Florida
Floats, Inc.
dba Bellingham Marine

January 13, 2014

Re: Ft. Pierce City Marina- RFP No. 2013-021

Per our meeting on Monday December 30, 2013, I have reviewed and made the corrections listed below in items 1-7.

Attachment A.1

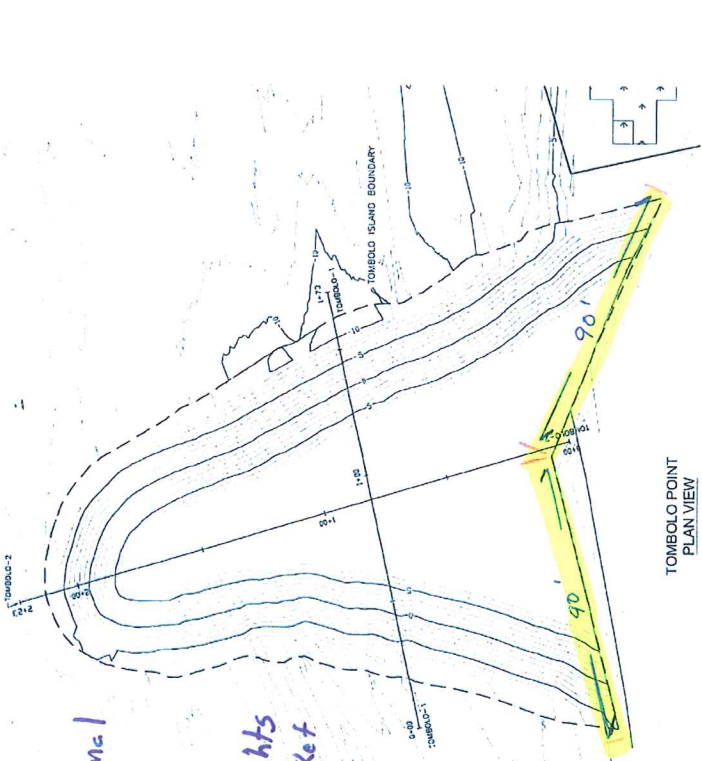
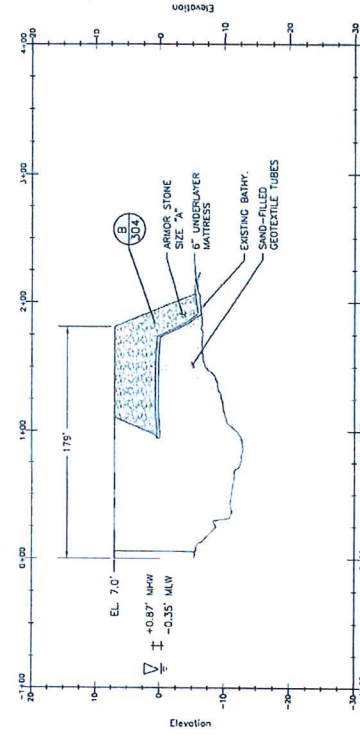
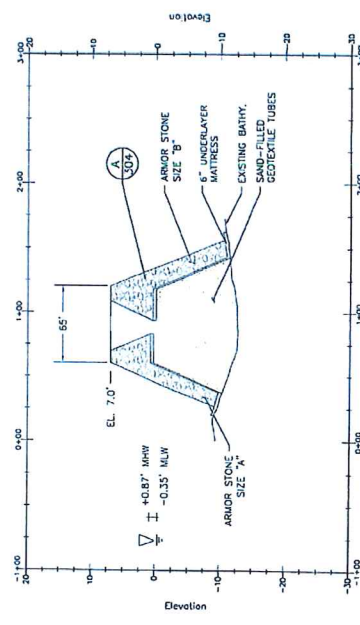
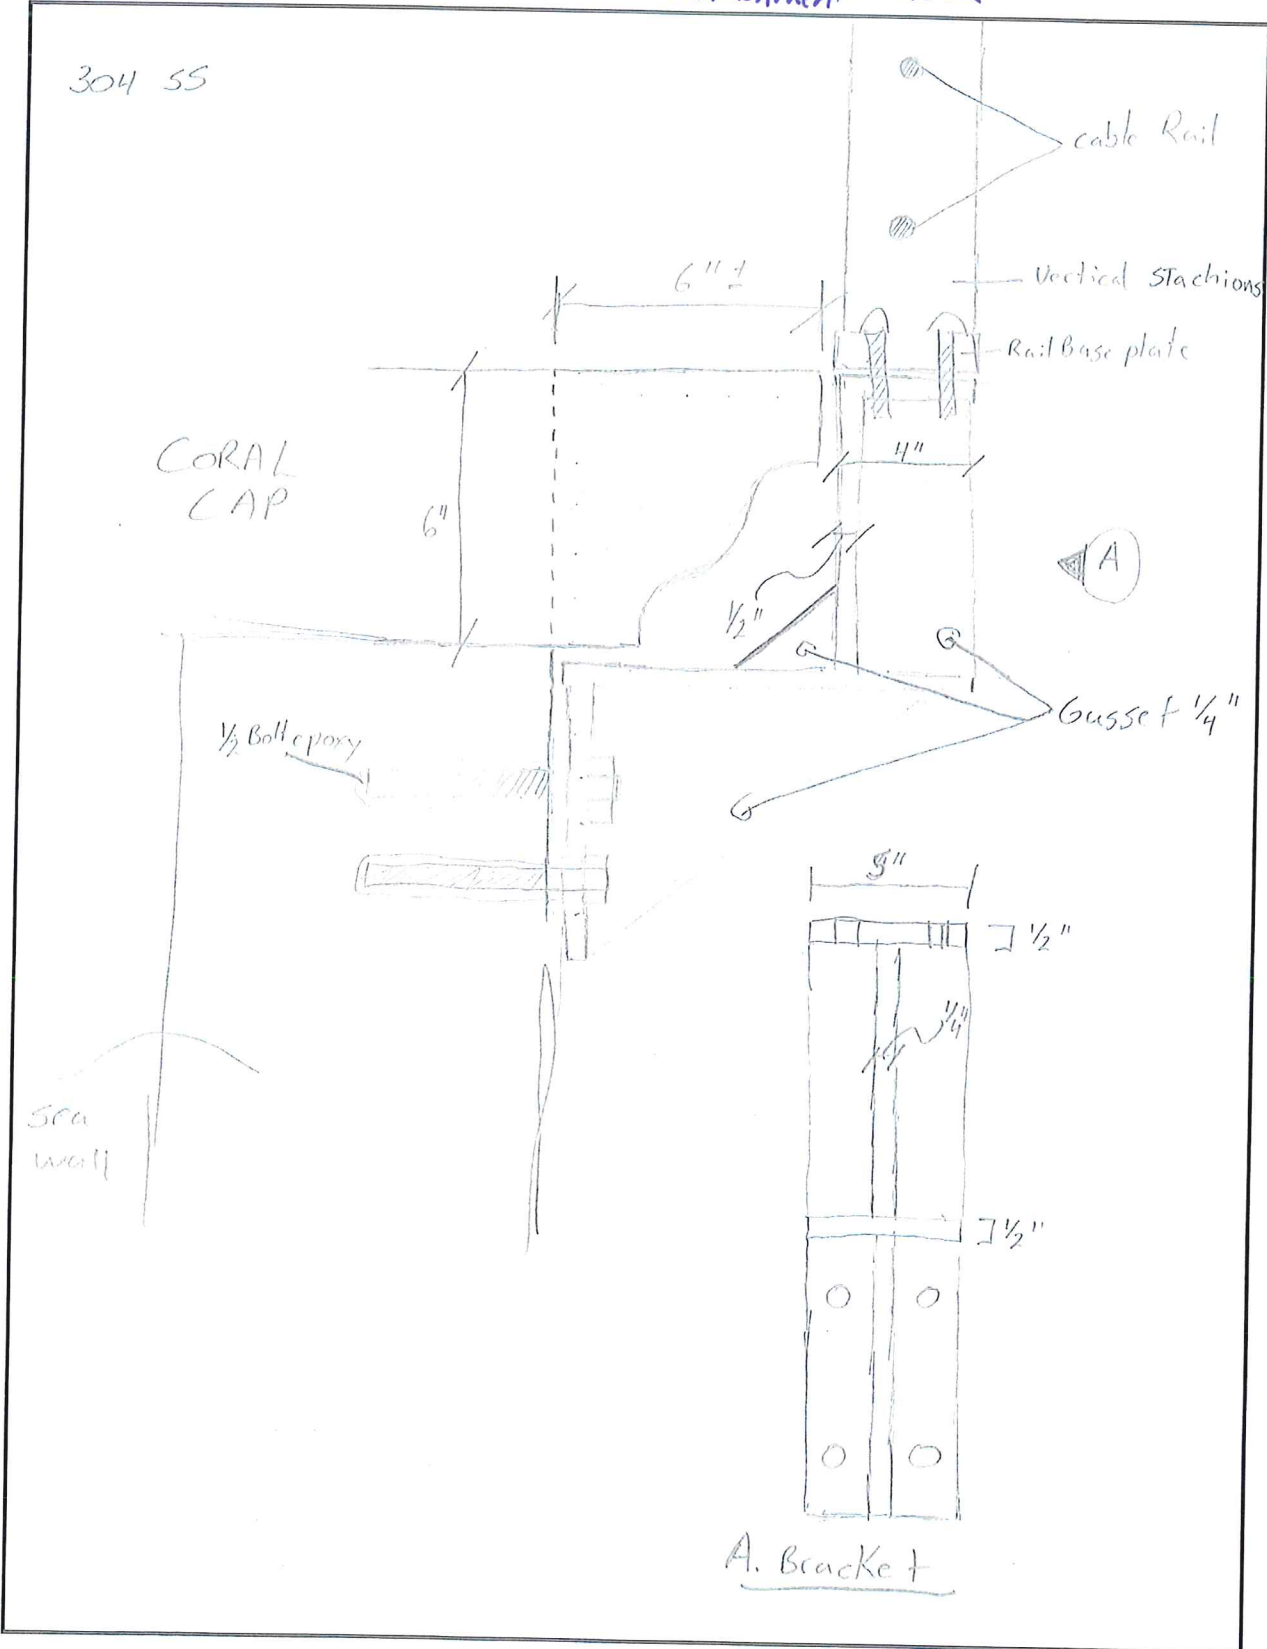
1. Additional Handrail at the southernmost jetty of approximately 180 linear feet of rail per (Attachment A.1 & A.2). The cost for the 36" tall line rail with no LED lighting and 304 SS wall mounting brackets is \$195.00 per linear foot. The approximate total for this scope is.....\$35,100.00

= Proposed Additional Handrail
90' + 90' = 180'
36" fall.
No under-rail lights
Use 30x55 bracket to support rail.

Attachment A.2

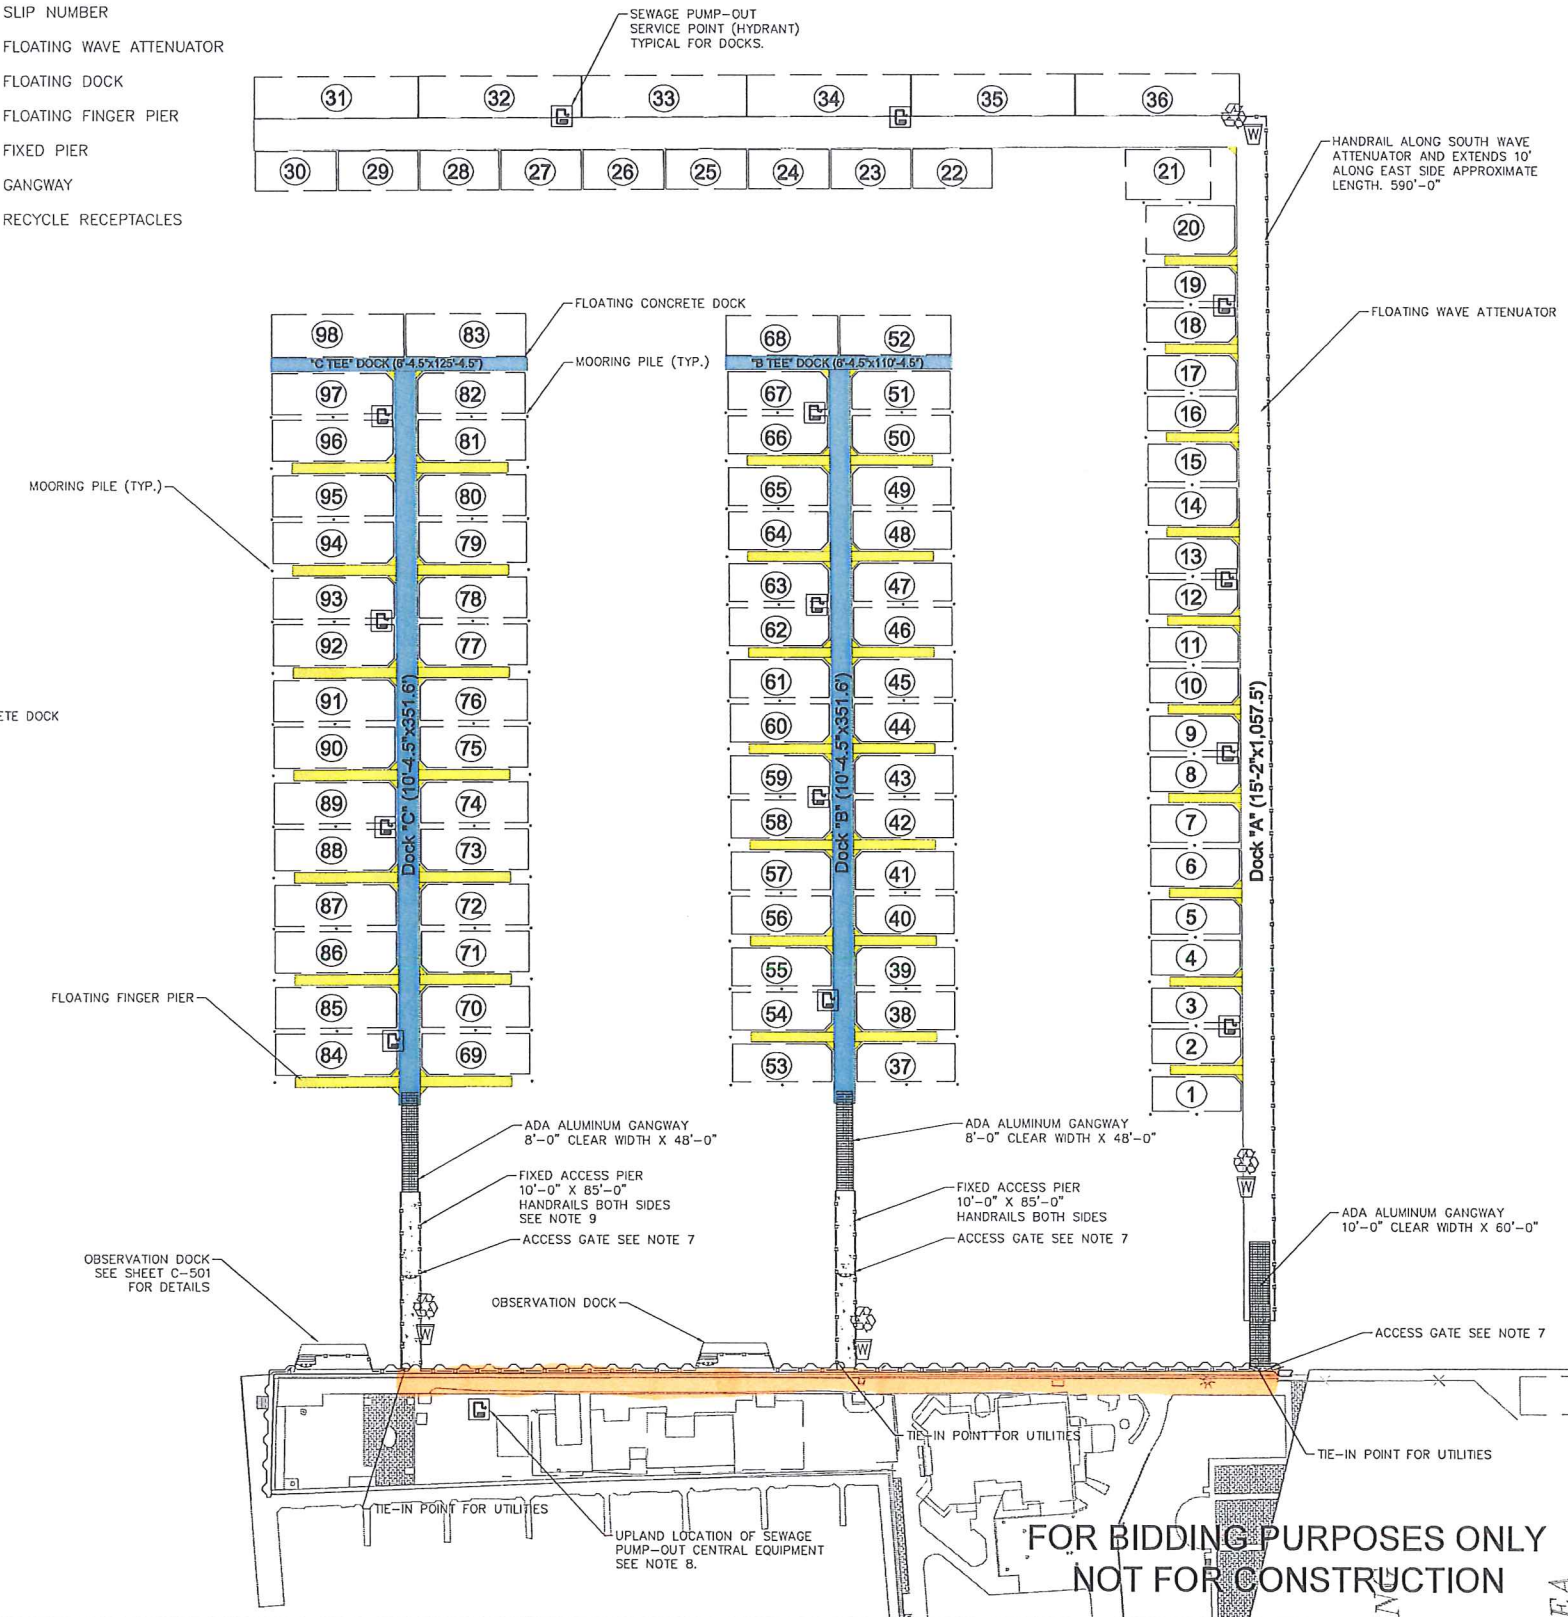
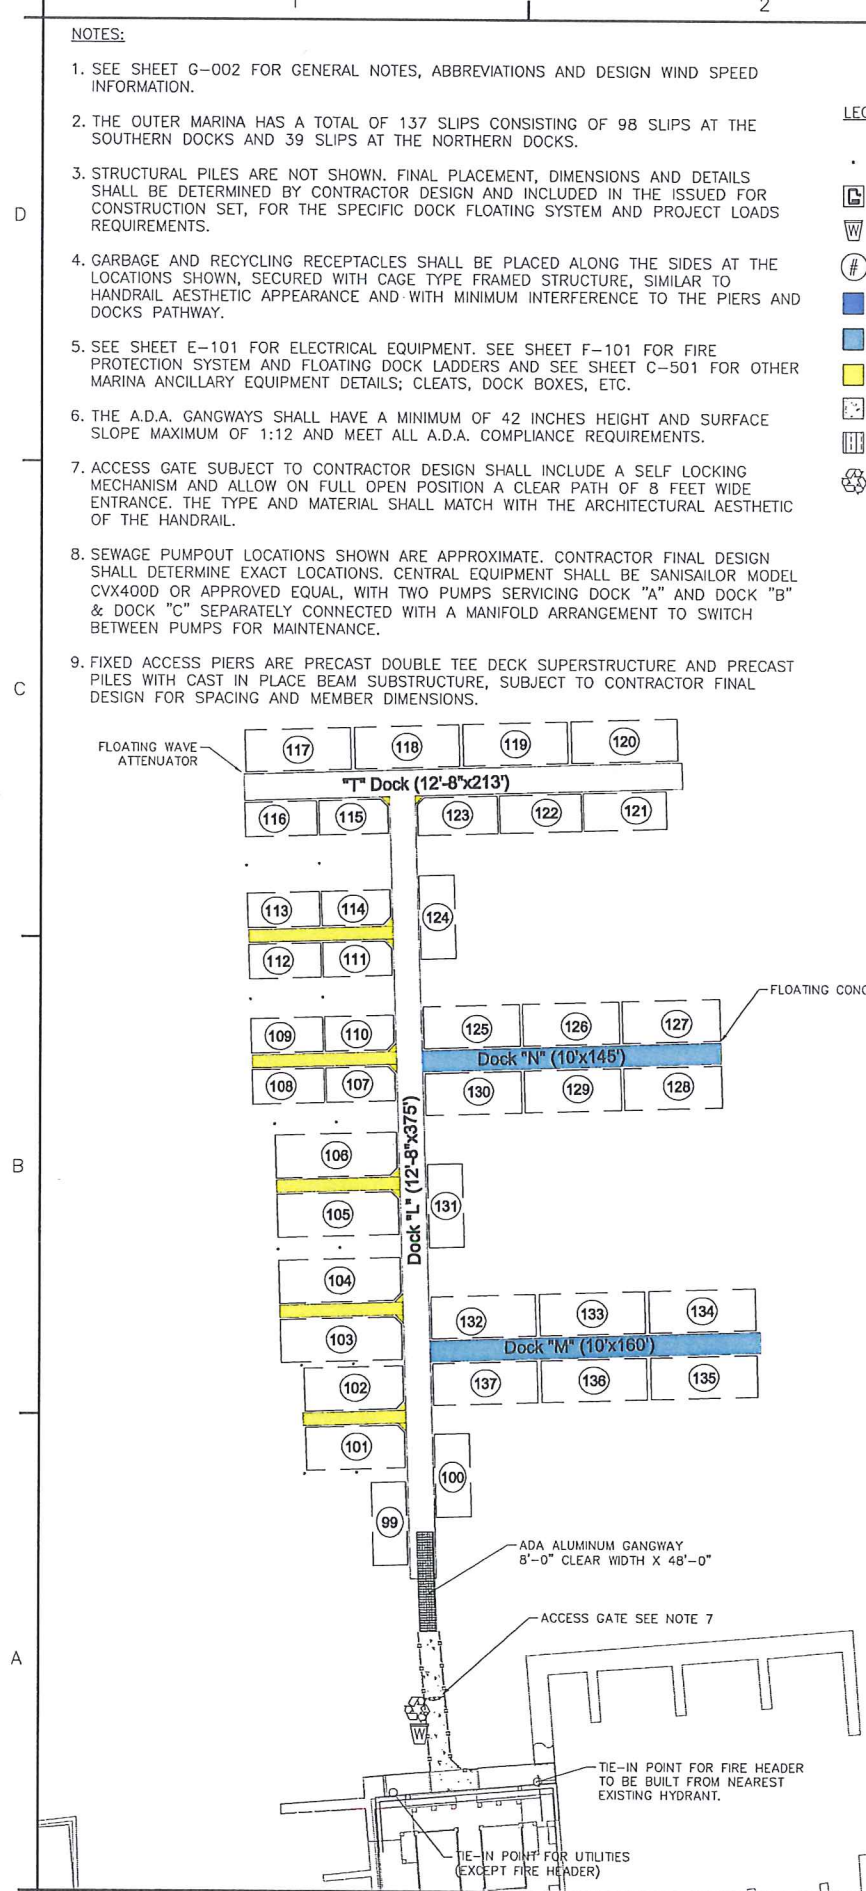
2. Removal and reinstallation of marina sidewalk from A Dock to C Dock (Attachment B). The side walk will be removed and the reinstallation of 4" 2500psi\$91,070.05

Orange Box = Limits of Sidewalk removal & Replacement
 Face of Sea wall curf to Face of Buildings
 Approx. 9' wide

Sheet Reference:
C-103
 Sheet 6 of 12

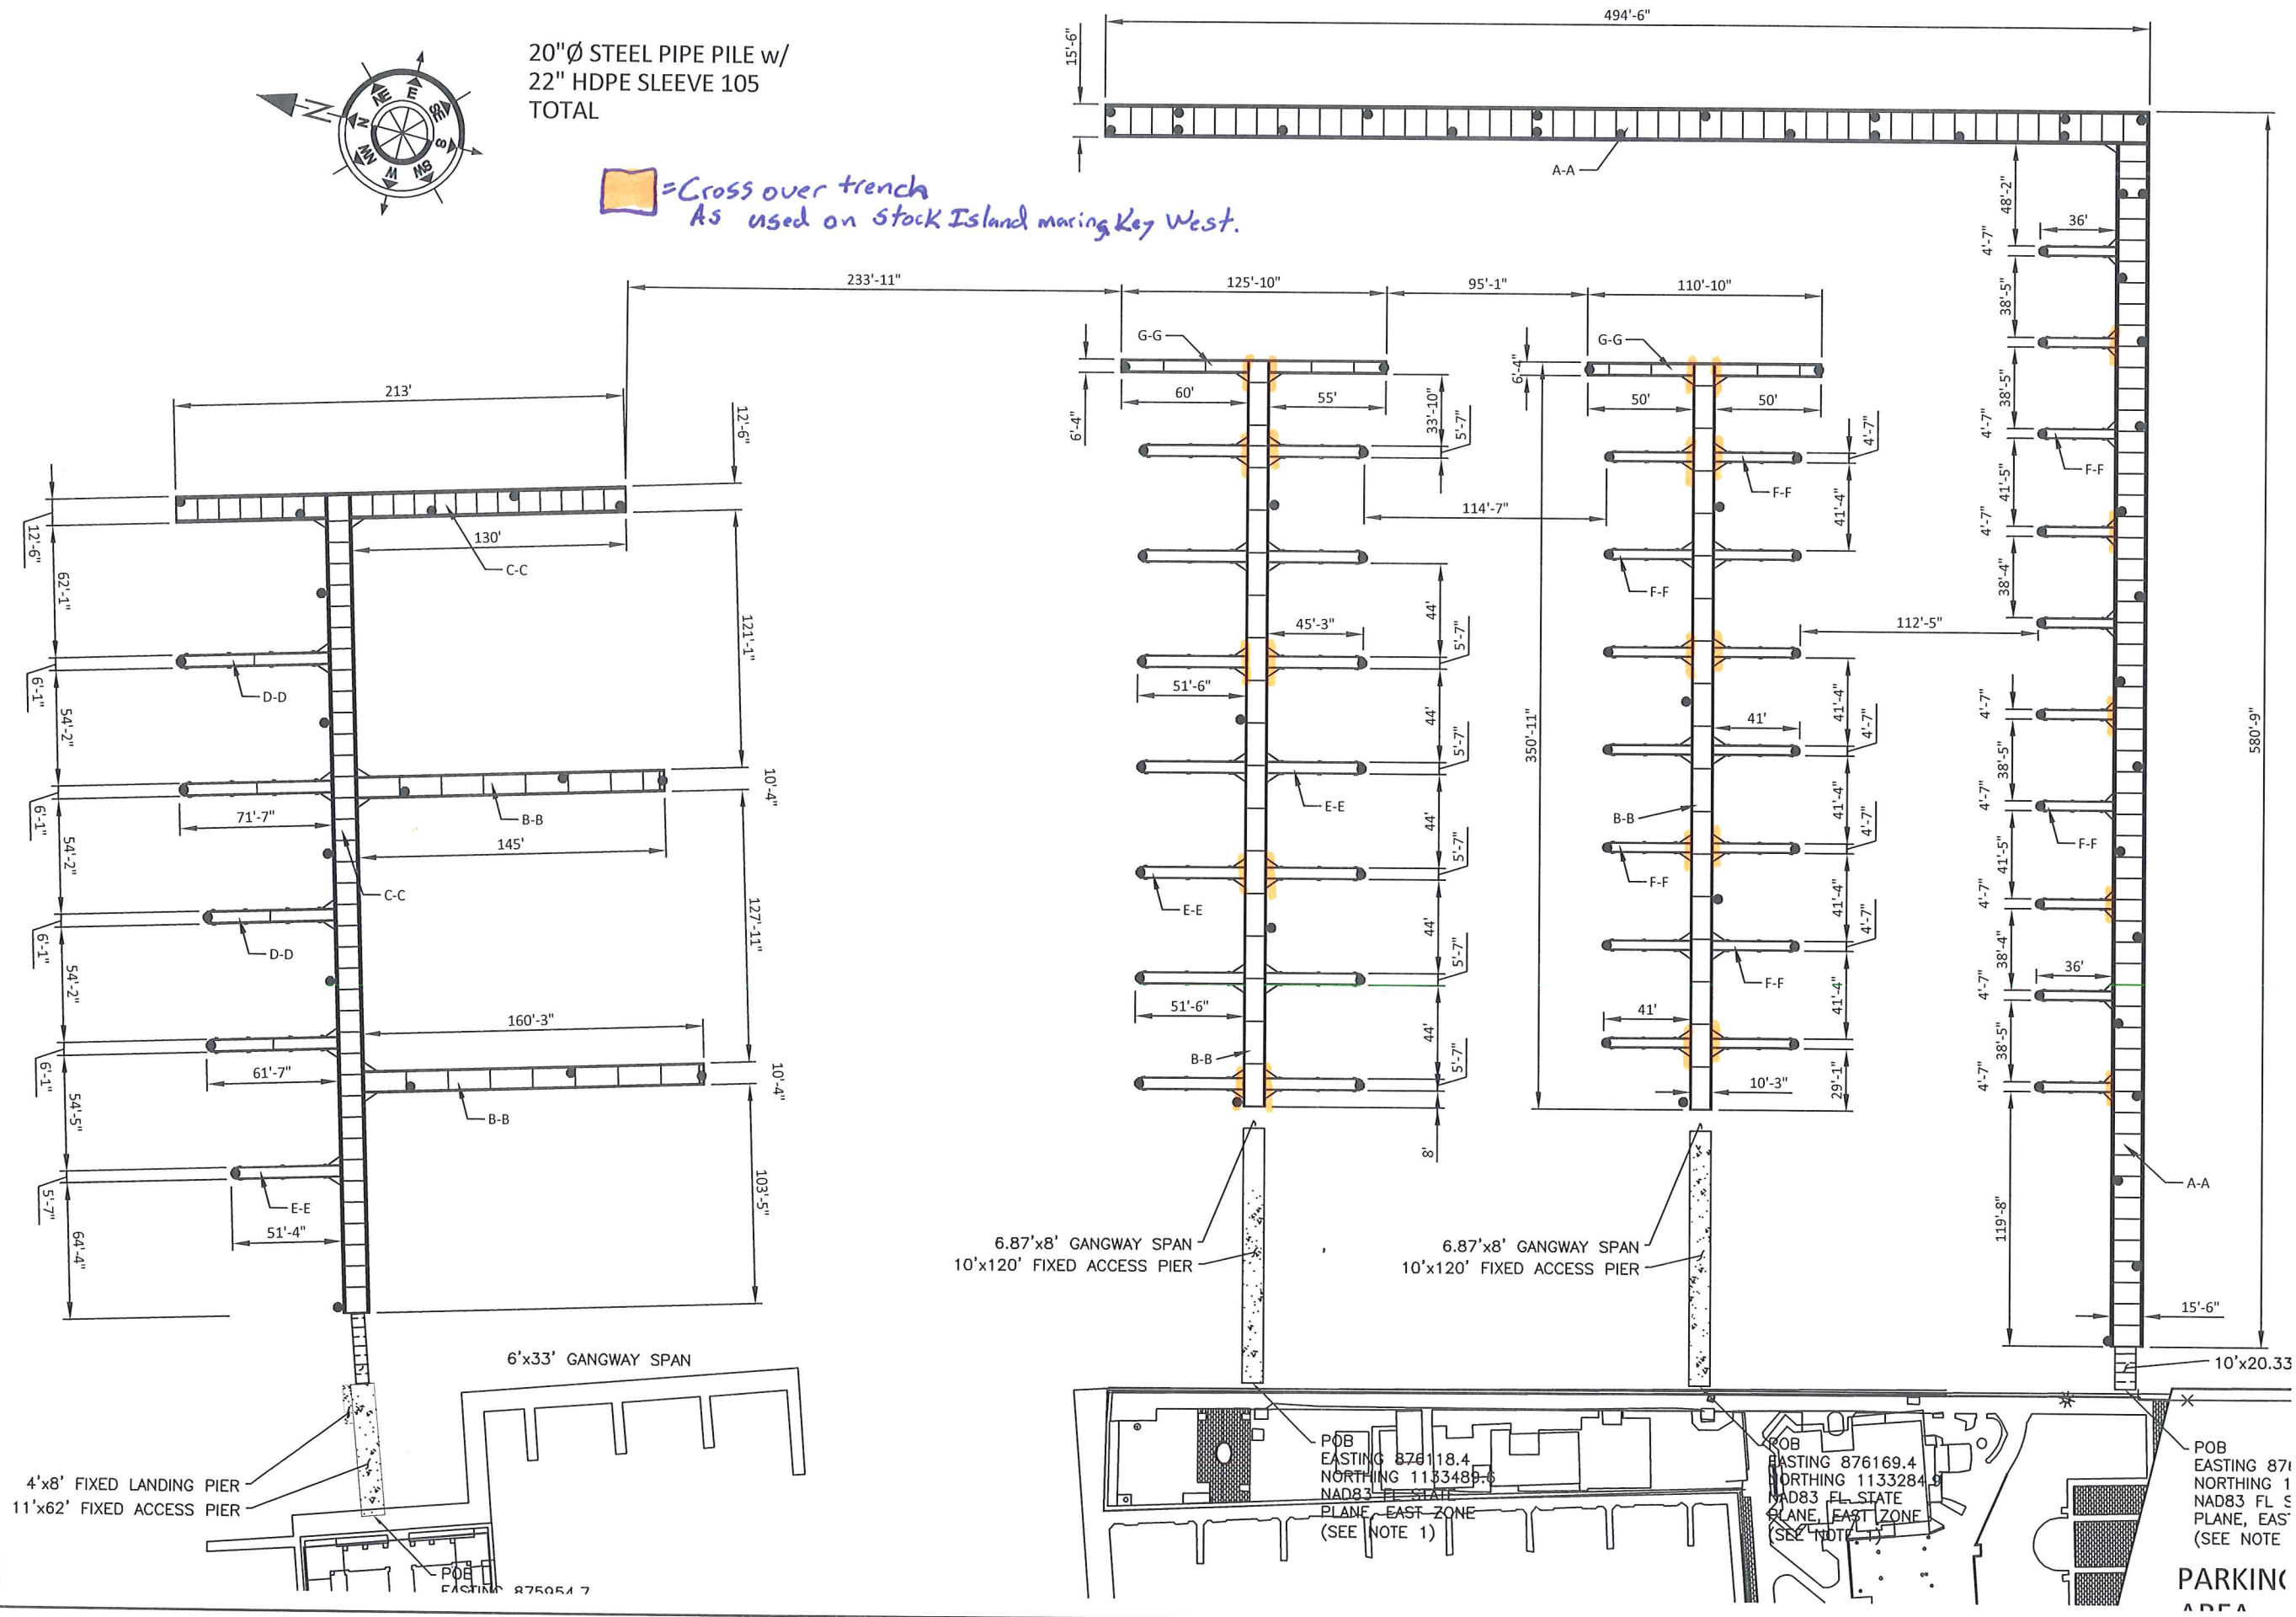
7. Walkway pile- During our review of the drawings for the marina on December 30, 2013, we were reviewing the original bid drawing for the 20" steel pile. Attachment C reflects the revised bid drawing for the project containing 105 total Steel piles. The revised drawing shows pile along the main walkways and is per the below reference base bid Alternate #2.

20"Ø STEEL PIPE PILE w/
22" HDPE SLEEVE 105
TOTAL
